Valve, Common Rail, Removal
AN, CHU, CXU, GR, GU, PI, MRU, LR, TE
MP7, MP8

FSB 237-021, Valve, Common Rail, Remove

(May 2021)

Some MACK vehicles built with MP7 or MP8 engines between 11/14/2016 and 05/04/2020 may experience internal leakage or an electrical fault of the Electronic Pressure Relief Valve (ePRV).

T2170580

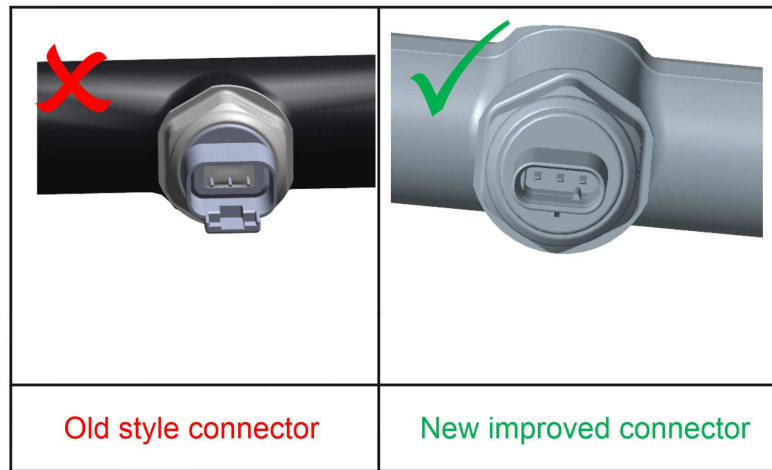
17 A product improvement has been made to the Fuel Rail Pressure Sensor (FRPS) and its wiring harness. A visual inspection of the FRPS electrical connector will indicate which sensor and wiring harness is on the vehicle.

18 Inspect the FRPS, if the Old Style Connector is found (displayed above with red X), replace the sensor and wiring harness per Impact Instructions listed below. If the New Improved Connector is found, **No further action is needed and proceed to next step.**

1. Refer IMPACT document ID: **2373-03-03-06 Pressure Sensor, Common Rail, Replacement, Valve Cover Removed** for pressure sensor replacement.

2. Refer IMPACT document ID: **2861-03-03-03 Wiring Harness, Injector, Replacement (Rear), Valve Cover Removed** for injector wiring harness replacement.
